United States Patent and Trademark Office

APPLICATION NO.	FILING DATE	FIRST NAMED INVENTOR	ATTORNEY DOCKET NO.	CONFIRMATION NO.	
10/690,026 10/20/2003		Huo-Pia Wang	08688.0331US01	08688.0331US01 4013	
23552 7	590 01/03/2006	EXAMINER		INER	
MERCHANT & GOULD PC P.O. BOX 2903		DOAN, ROBYN KIEU			
MINNEAPOLIS, MN 55402-0903			ART UNIT	PAPER NUMBER	
	,		3732

DETAILED ACTION

TEASING COMB

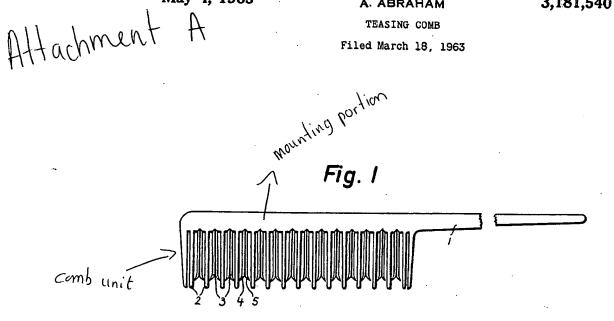
Wit regard to claim 1, Abraham discloses a comb (figs. 1-2) comprising a body including a hand-grip portion (1) and a mounting portion (see attachment A) that extends from the hand-grip portion in a longitudinal direction, a comb unit (see attachment A) securing to and projecting outwardly from the mounting portion and including a plurality of spaced apart combing plates (6) which are aligned in the longitudinal axis, a plurality of auxiliary combing members (7) which are aligned with the combing plates in the longitudinal direction and which are alternately disposed with the

combing plates (fig. 1), each of the plurality of auxiliary combing members having a plurality of ribs (8, 9) aligned in a transverse direction relative to the longitudinal axis direction, see fig. 1. Each of the ribs having a top portion, top portions of two adjacent ones of the ribs angling from each other (see attachment A) in a longitudinal direction and defining a V-shaped groove there between.
